Model Series 463 AMG: Active Distance Assist and Active Brake Assist IC Message and DTC U0416FE

Topic number	LI54.71-P-078112
Version	6
Function group	54.71 - Camera and radar-assisted assistance systems
Date	10/29/25
Validity	463 AMG
Reason for change	Updating parts.

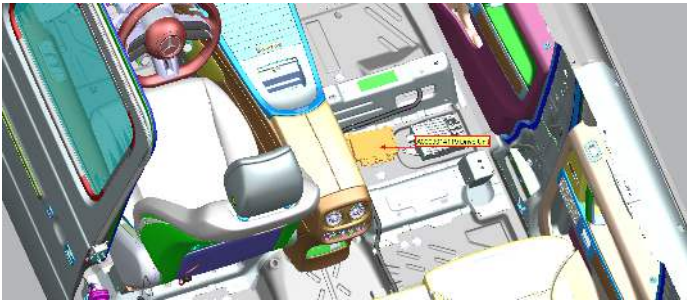
Missing wire between Drive Unit (N145) and Supercap (C8).

Professionally create a new connection by:

- Using a red/white cable with cross-section 0.35 mm² and overall length of approximately 2m.
- Connect Drive Unit (N145) plug A pin 18 to the 3-pin plug of the Supercap (C8) terminal 15 pin 2. Reference the new wire routing location as shown by the red line in "Picture 1 - Connection from Supercap to Drive Unit".
- The new wire should be added to the existing wiring harness as shown by the red line "Picture 1 - Connection from Supercap to Drive Unit".
- Z-Splice is the preferred method using A 000 982 91 10 for the Supercap (C8) connection.
